MOUNTAIN'S EDGE

FINAL PLAT
MOUNTAIN'S EDGE

FINAL PLAT MOUNTAIN'S EDGE

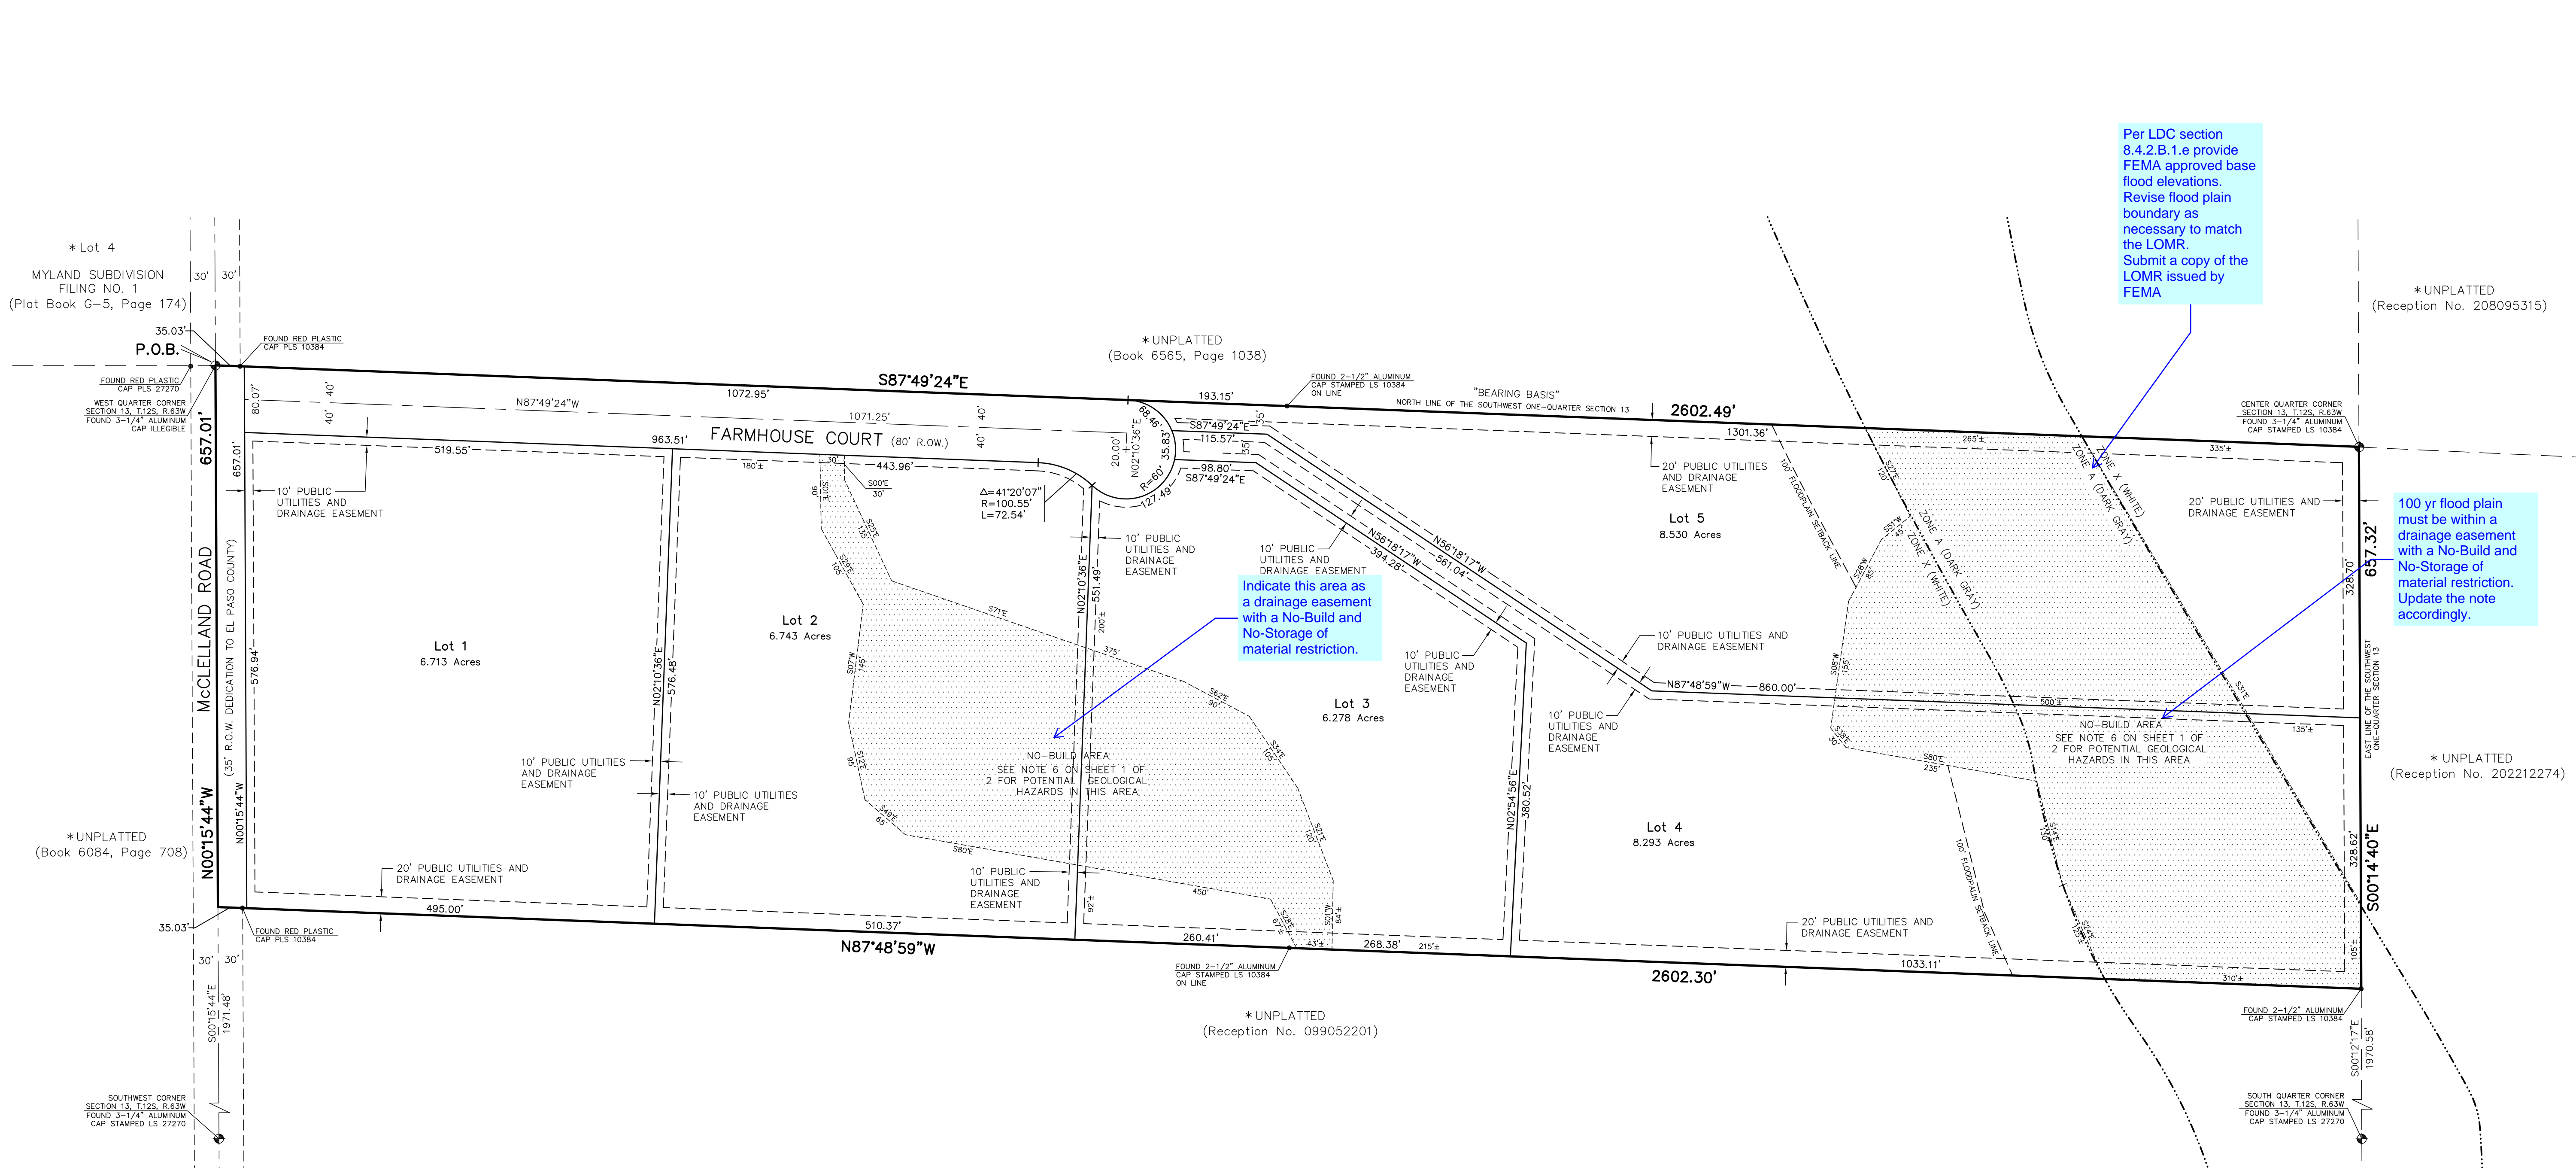
Per LDC section 8.4.2.B.1.e provide FEMA approved base flood elevations. Revise flood plain boundary as necessary to match the LOMR. Submit a copy of the LOMR issued by FEMA

Indicate this area as a drainage easement with a No-Build and No-Storage of material restriction.

100 yr flood plain must be within a drainage easement with a No-Build and No-Storage of material restriction. Update the note accordingly.
